Request for Additional Information  
Holtec International  
Docket No. 71-9375  
HI-STAR ATB 1T Package

By letter dated February 6, 2017, Holtec International (Holtec) submitted an application for Certificate of Compliance No. 9375, Revision No. 0, for the Model No. HI-STAR ATB 1T package. By letter dated April 14, 2017, Holtec responded to a request for supplemental information (RSI) letter dated March 21, 2017. The application was accepted for review on May 10, 2017.

This request for additional information (RAI) identifies information needed by the U.S. Nuclear Regulatory Commission staff (the staff) in connection with its review of the HI-STAR ATB 1T package application to confirm whether the applicant has demonstrated compliance with regulatory requirements.

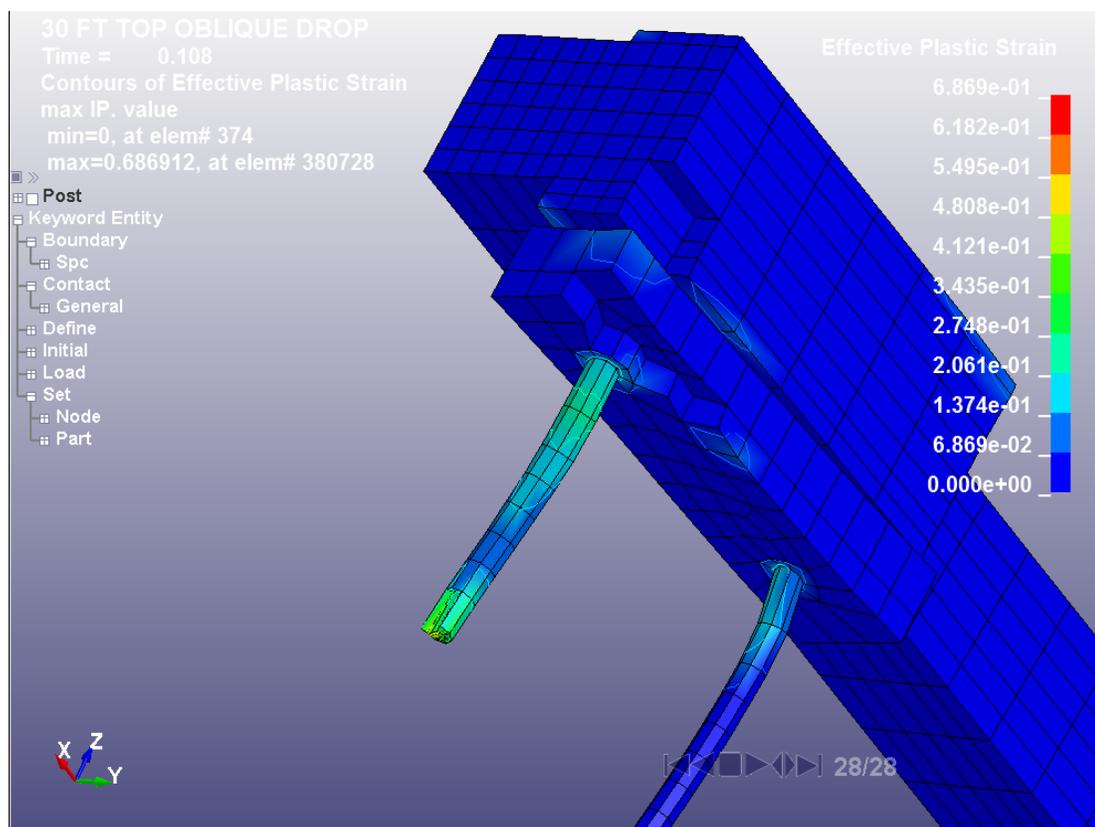
- 2-6 Clarify the dimensions and the modeled properties of the cask wedge blocks depicted on licensing drawings used in LS-DYNA simulations for both the prototype and ATB 1T. Sheet 2 of Drawing 9786 of the ATB 1T depicts cask wedge blocks (BOM 11) in relationship to the top flange (BOM 2) under the view "closure lid wedge system". It appears that the cask wedge blocks are tapered 4° and forced against an equally tapered 4° closure lid locking wedge (BOM 9 and 10).

According to Section 2.3 of the application, shims will also be installed against the cask wedge blocks. This similarly applies to the prototype as well, as shims were used at the location of the wedge blocks. Since the cask wedge blocks help maintain a positive closure on the seals of the package:

- a) Describe why wedge blocks (BOM 9 and 10) are not modeled with a 4° taper.
- b) Provide the compressive stress (sealing force) expected on the seals (BOM 7) and the sealing surface of the flange (BOM 2) when the lid (BOM 8) is fully engaged by closure lid locking wedges (BOM 9 and 10). The expected compressive force (if any) should be incorporated into LS-DYNA simulations, supported by calculation, and tractable with respect to an installation procedure.

It is noted that the procedure used to ensure this sealing force is key to keeping the containment boundary intact and should be deployed reliably when operating the package.

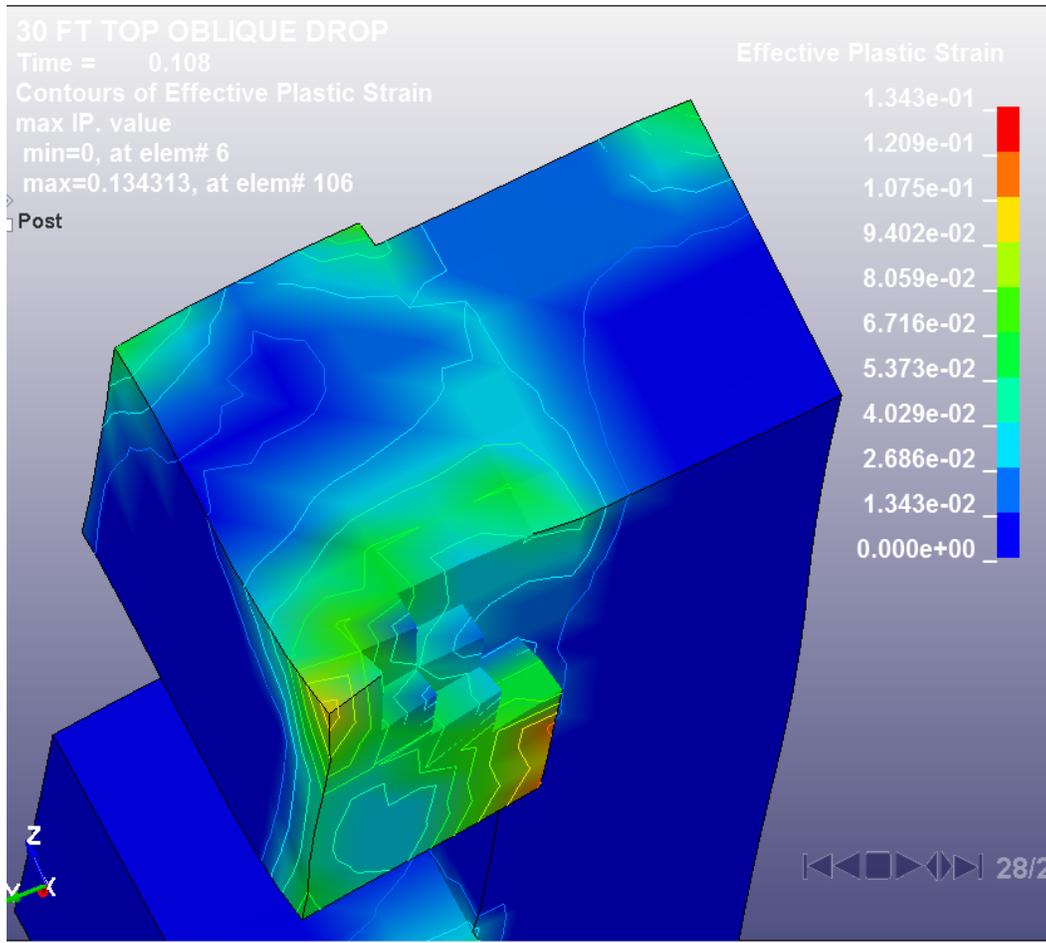
Section 2.1.2.2 of the application states that the acceptance criteria for the closure lid locking mechanism is such that it should not undergo gross yielding. For at least one LS-DYNA simulation, the 30 ft oblique drop appears to depict gross yielding of the closure lid locking wedge along with some material failure. The missing material is depicted below:

Gross yielding is assumed here to have occurred because a plane can be passed through the end of CLLS, and encounter effective plastic strain throughout that plane.

Clarify how this acceptance criteria is met in this instance and why the criteria is valid. It could be argued that the CLLS can undergo partial inelastic yielding (not gross) and cause a breach in containment. For instance, one face of the CLLS could suffer uniform material failure allowing the lid to become loose.

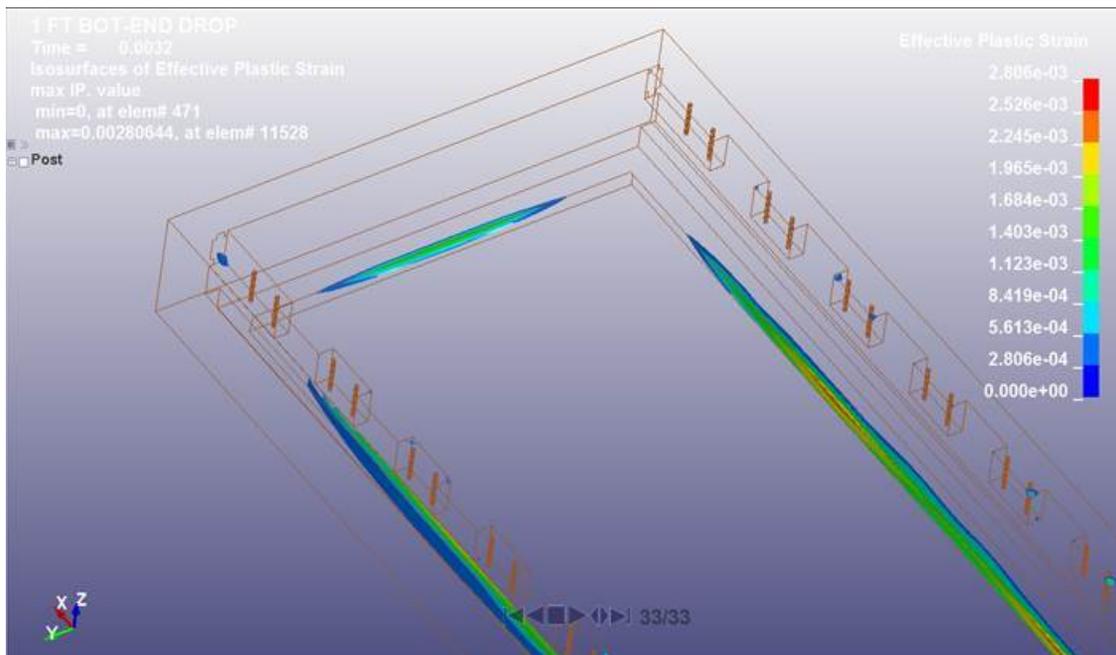
Page 2-8 of the application mentions that strain-based criteria cannot be applied to the landing area of the top flange (BOM 2) and of the closure lid (classified as Zone B). LS-DYNA simulations for both the bottom end 1 ft drop (NCT) and 30 ft bottom end drop (HAC) report inelastic deformations around the flange landing as depicted below (1 ft bottom end drop shown):

The flange landing in LS-DYNA has been modeled as 3.125" wide, where in the licensing drawings the landing is depicted as being only 2.5" wide. It is expected that, if a value of 2.5" had been used, higher degrees of inelastic deformation would have been reported by LS-DYNA.

In addition, higher strains may exist for HAC conditions as a result of rigid body assumptions of the contents at the flange. Specifically, the closure lid is unable to fully flex during the simulation due to contact with the contents, resulting in excess forces being transferred through the contents rather than the landing where the seals are located. The applicant shall:

- a) Update LS-DYNA puncture and free drop model with regards to flange dimensions,
- b) Describe the seal/flange landing performance as a function of rigid body assumptions.

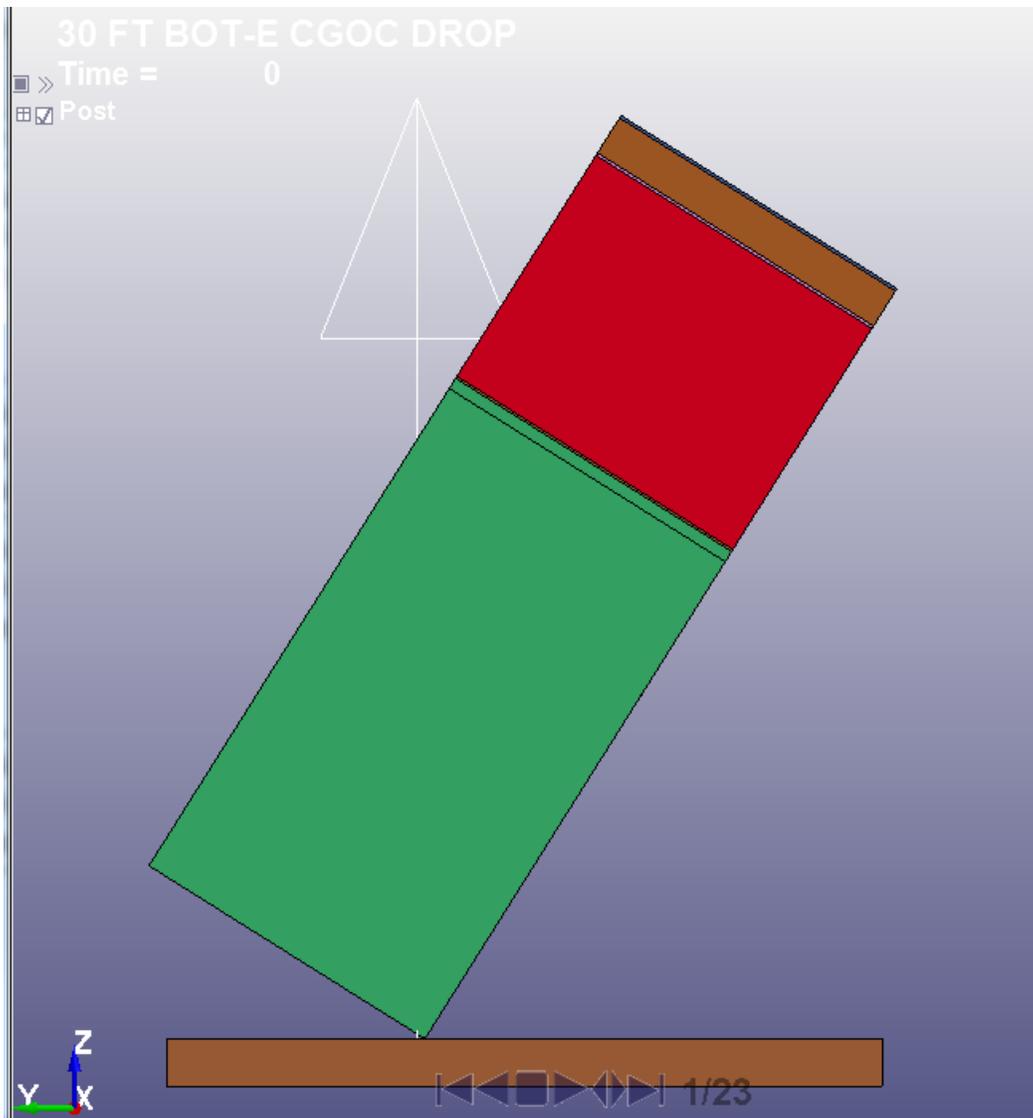
The HI-STAR ATB 1T center of gravity is located relatively close to its geometric center. An arrow drawn normal to the target and close to the point of impact should pass through the center of gravity. It is expected that this fictitious arrow would pass through the center of gravity and close to the opposing corner of the package.

It appears that this may not be the case according to the picture below where the package is seen to be leaning too far to the right from the arrow.

Verify that the package orientation for the CGOC simulation is correct.

Update all drop/puncture LS-DYNA simulations for the HI-STAR ATB 1T for NCT and HAC conditions as appropriate.

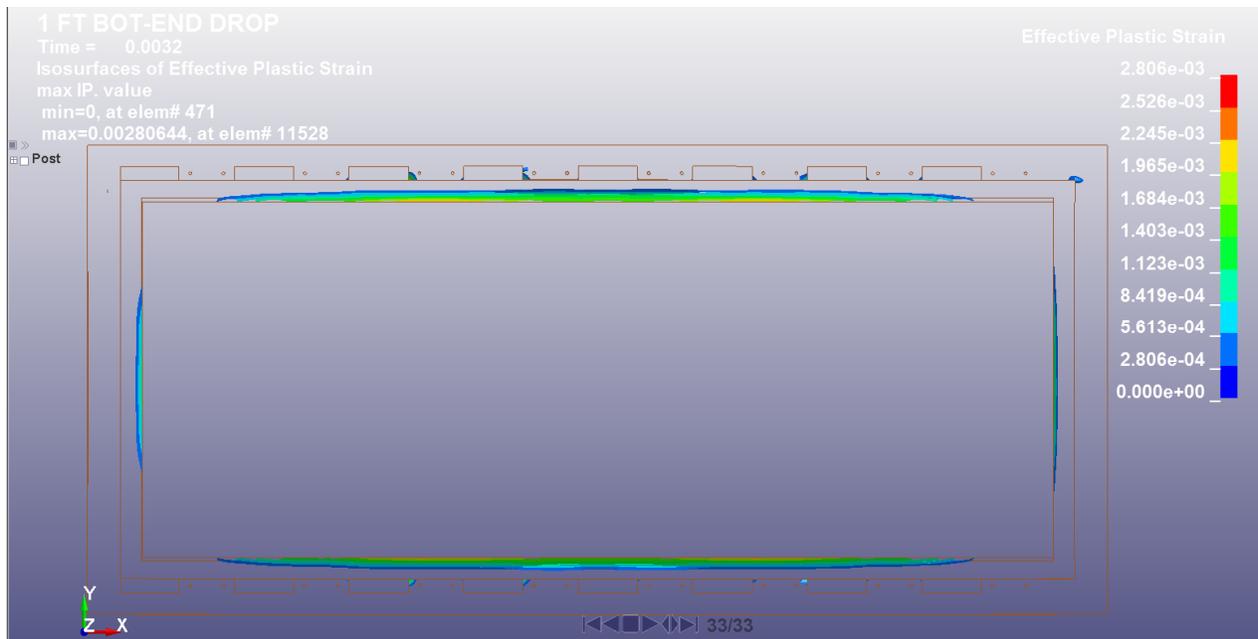
There was limited discussion of the heat transfer that occurs after the 30-minute fire and during the 1.5 hour cooldown; thus, a review could not be performed.

Figure 5-8.1

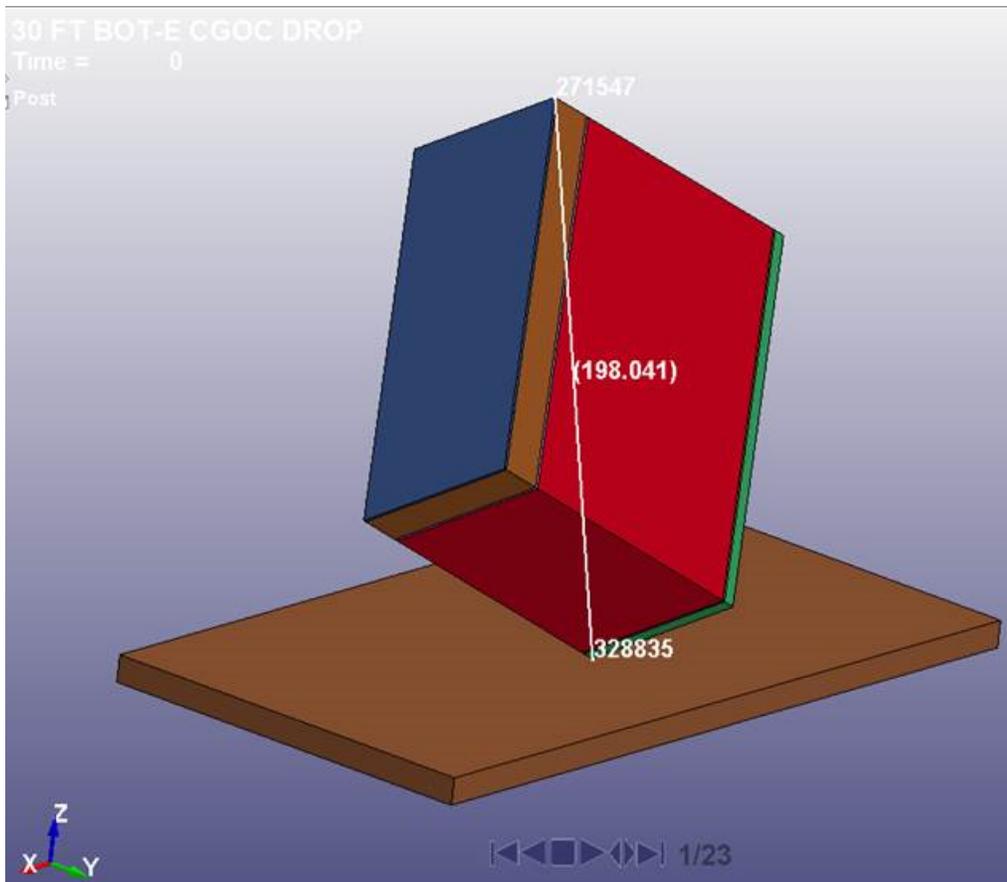
Although the staff agrees that the deformation experienced after the pin puncture would likely have a negligible impact on the dose rate at 1 meter given the margin to the limits, the staff finds that there is significant inelastic deformation, in addition to some loss of material (element erosion), that occurs at the corner directly impacted during the bottom 9m CGOC free drop simulation in LS-DYNA. Figures 5-8.1, 5-8.2 and 5-8.3 below illustrate the extent of inelastic deformation by tracking the change in length of the imaginary line between two points on the package as a function of time: the impacted corner, and the corner on the opposing corner of the package. The graph implies that the struck corner deforms as much as 7 inches during the simulation relative to its pre-impact location terminating, with more than 4 inches of permanent deformation (note element erosion at the impact site around node 328835). Note that other measures could also indicate additional information.

The applicant needs to provide a dose rate analysis demonstrating that the simulated deformation and material loss would not cause an increase in external dose rates beyond regulatory limits, while concurrently considering the streaming from conditions of the BFA-tanks and BTC (see RAI 5-5).
